Product Change Notification

PCN26-45 Changes to select items from QHPS Series of Linear DIP Switches

Revision	Date	Description	Author
A	24 Sep 2026	Creation	Grace Li

- i. Production line relocation from Xinyu city, Jiangxi province (China) to Yueqing city, Zhejiang province (China).
- ii. Product appearance:

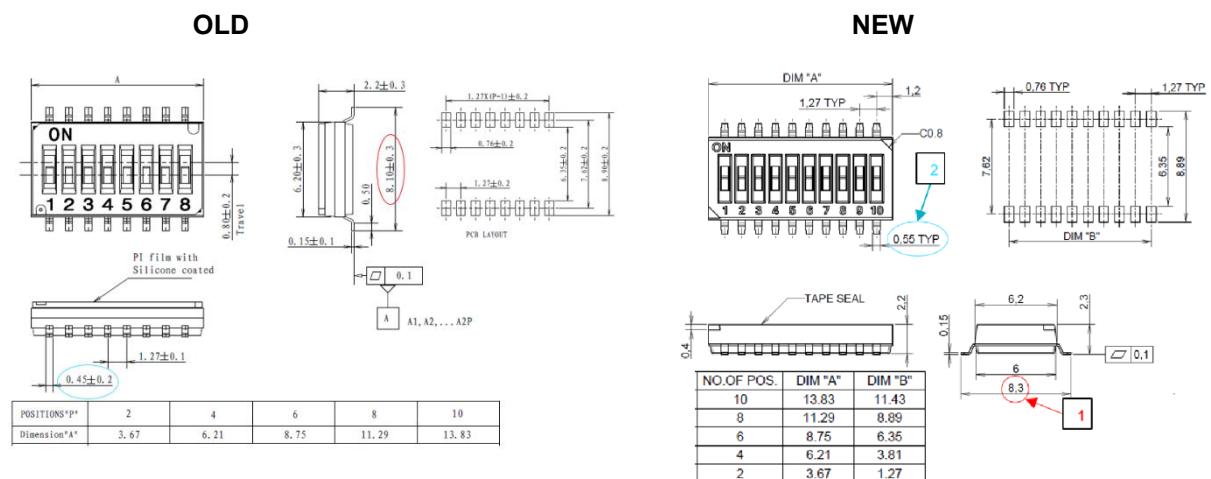
Difference points: 1. Chamfering position
2. Terminal bending
3. Cover shape
4. Surface gate
